Subject: Phase I Bond Release Application, Alton Coal Development, LLC, Coal Hollow Mine, C/025/0005, Task ID #4788

Technical Analysis and Findings

PID: C0250005
TaskID: 4788
Mine Name: COAL HOLLOW
Title: PHASE I BOND RELEASE

Table A:

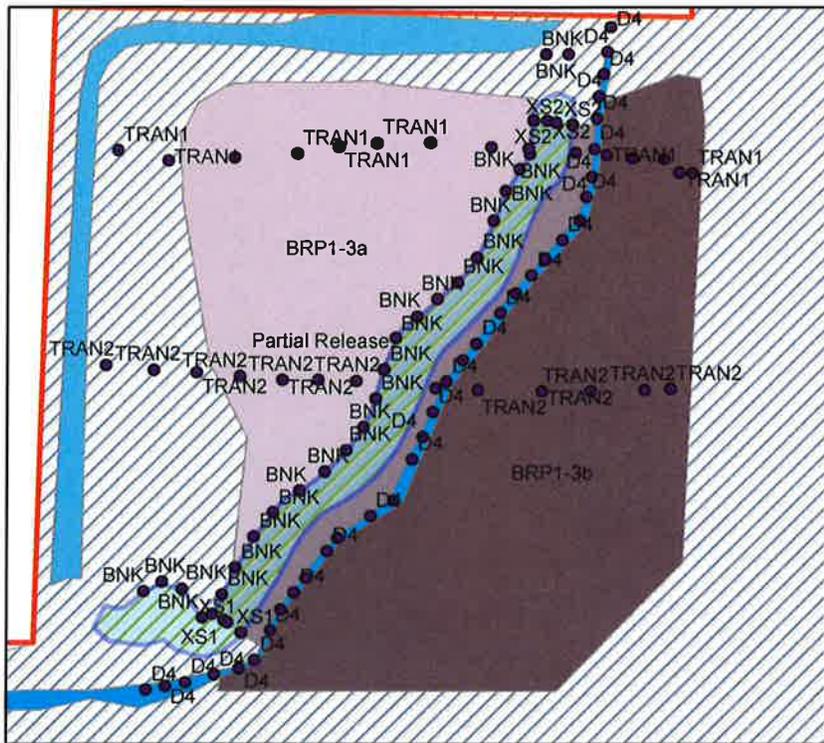
- The area detailed as BRP1-3 on Figure 1 within the application contains the Lower Robinson Reconstruct. The Lower Robinson Reconstruct is currently still being built and is tied to a pending abatement plan for NOV#16149. The current design has yet to be approved by the Division. The abatement design also has additional work tied to it to meet the R645-301-552 Permanent features regulations. In addition there is earthwork associated with the removal of the northern "plug" at final reclamation. The section of BRP1-3 that contains Lower Robinson Creek reconstruct does not meet the requirements of R645-301-553 for phase I bond release. R645-301-880.310 states "At the Completion of Phase I, after the operator completes the backfilling and regrading and drainage control of a bonded area in accordance with the approved reclamation plan, 60 percent of the bond or collateral for the applicable area". Again, Robinson creek reconstruction is still under construction, backfilling, and regrading actives of the area will directly impact the bond release area adjacent to the construction site. The Division staff on May 5, 2015 determined the area to be disturbed during the final construction of Robinson creek and found the area to be approximately 3.5 acres, as shown on Figure A and Table A.

MRP cost estimate states that volume of 1, 089 cubic yards will be required in the final grading of Ditch 4 disturbing an area of 0.8 acres, as shown on Table A.

PROJECT	MINE	Ref.	FIGURE
Coal Hollow	Alton Coal Development	C/025/005	A

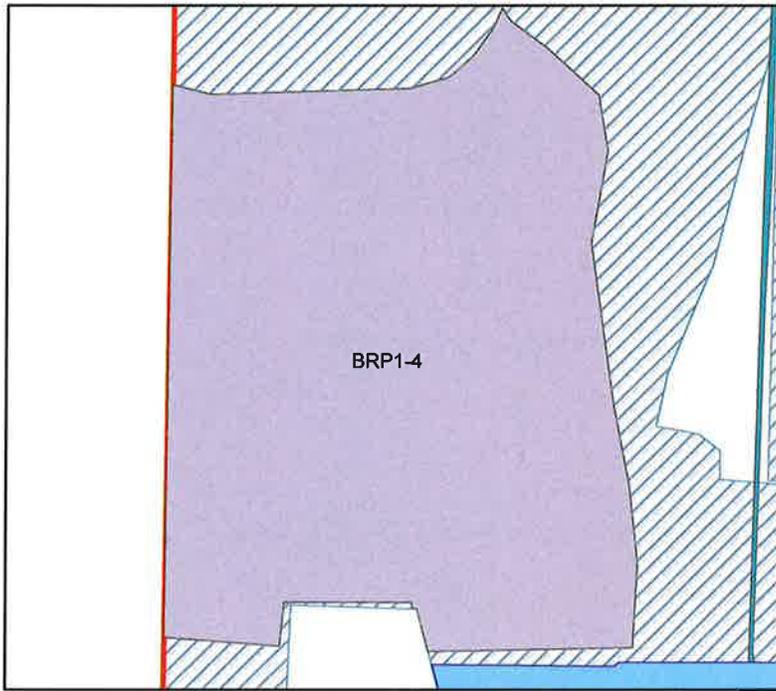
The Division will consider a bond release application for the areas shown on the attached Figure A. Please provide topographic maps on a scale of 1:100 with 2 ft. cross-sections to allow interpretation of final elevations, slopes, and drainage for these distinct areas. Maps of this scale are customary in bond release application reviews and contemplated in R645-301-141 as well as outlined in Tech Directive #6.

Attached you will find the Division's Findings Form and Figure A which illustrates the bond release locations for which detailed cross-sections and maps are requested.

- Ditch 4 is also currently in the process of being reconstructed as designed in the MRP. The area associated with the ditch location will also need to be removed from the original BRP1-3 area. The section of BRP1-3 that contains Ditch 4 does not meet the requirements of R645-301-553 for phase I bond release due to the site not being at final backfilling and grade. An estimated area of 0.4 acres and 1,089 cubic yards is associated with the regrading and backfill of Ditch 4. The

The site BRP1-3 was surveyed by Division staff to determine the new area that meets the R645-301 on May 5, 2015 utilizing equipment accurate to within a centimeter. The Division approves the release of 26.2 acres and withholds approximately \$8,799 for the reclamation of Ditch 4 and Robinson Creek Reconstruction.

R645-301-830 and -301-880.310 are not met in in Area BR1-3 of the application. The Permittee failed to update the application letter with the new areas and relevant bond release amount. The Division will only approve a portion of the applied for area due the construction still required around Robinson Creek reconstruct and Ditch 4 at reclamation. Ditch 4 has an area 0.4 acres and 1,089 cubic yards in regrading associated with it and cannot be included in the bond release area due to this outstanding grading still required. Figure A and Table A detail the area, volumes, and cost associated with Ditch 4 and Robinson creek that do not meet the Division approval for bond release. The Permittee will provide updated as built maps and reflect this new areas within their bond release application.
